FIRE STATION NO.2 JSP26-17

Consideration at the request of HED | BRW Architects on behalf of City of Novi for Fire Station No.2 JSP26-17 for Preliminary Plan and Stormwater Management Plan review and approval of the location, character, and extent of the proposed improvements. The subject property is zoned RA Residential Acreage and is located north of Thirteen Mile Road and east of Novi Road (Section 2). The City proposes to develop a new fire station on the currently vacant 2.15-acre parcel.

PLANNING REVIEW

May 28, 2026
Fire Station #2
Preliminary Site Plan - Landscape

AS101

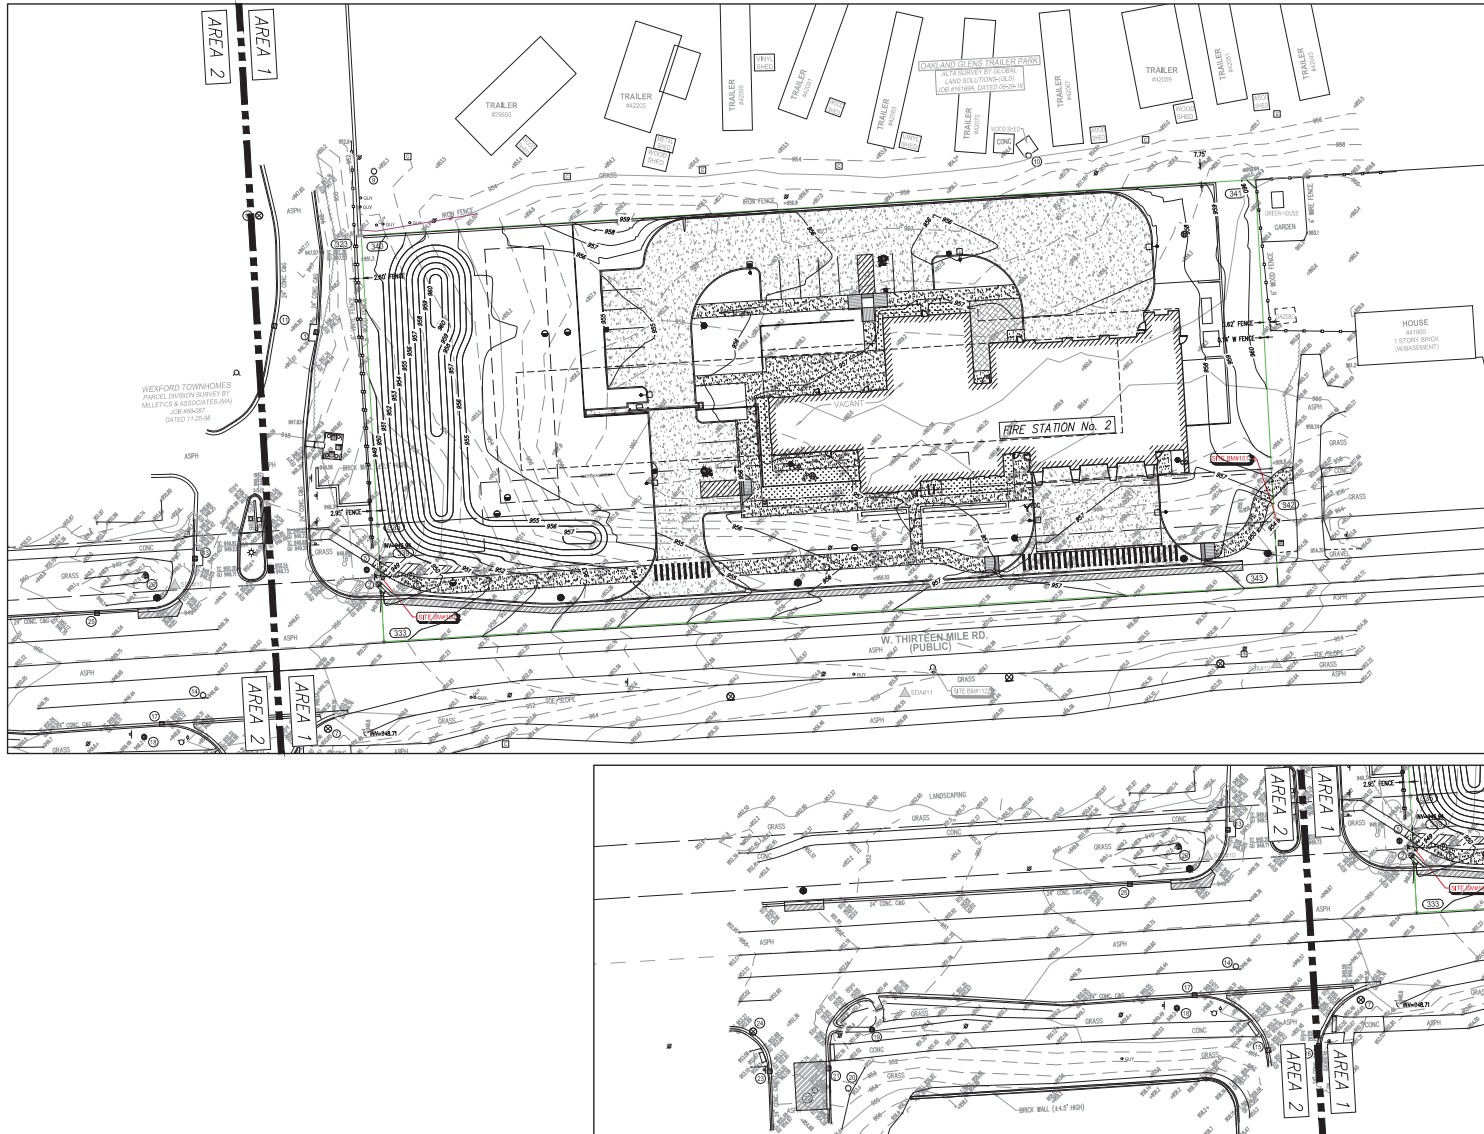
5. Parking space striping notes – Fix pavement marking labels at south accessible parking area on sheet AS101
HED/BRW Response: Noted – Final design plans will reflect correction.

Grading Plan
C6.1

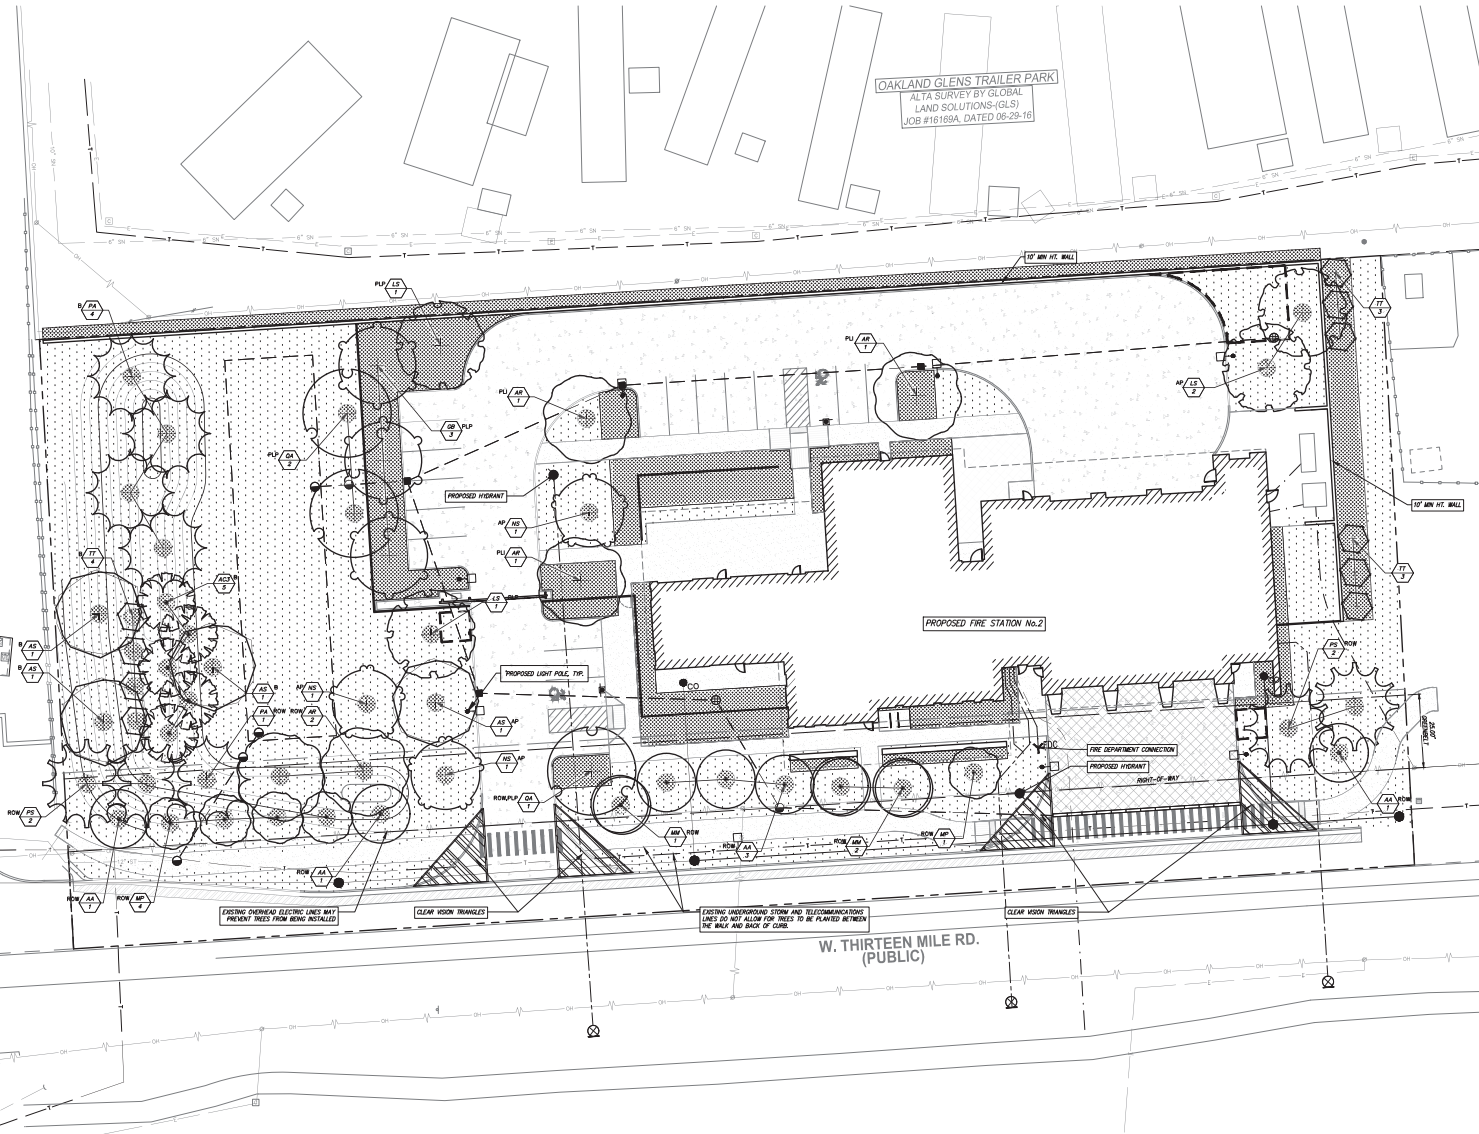
67. Provide additional spot grades as necessary to demonstrate that a minimum 5-percent slope away from the building is provided for a minimum distance of ten feet around the perimeter of the building.

68. The grade of the drive approach shall not exceed 2-percent within the first 25 feet of the intersection. Provide spot grades as necessary to establish this grade.
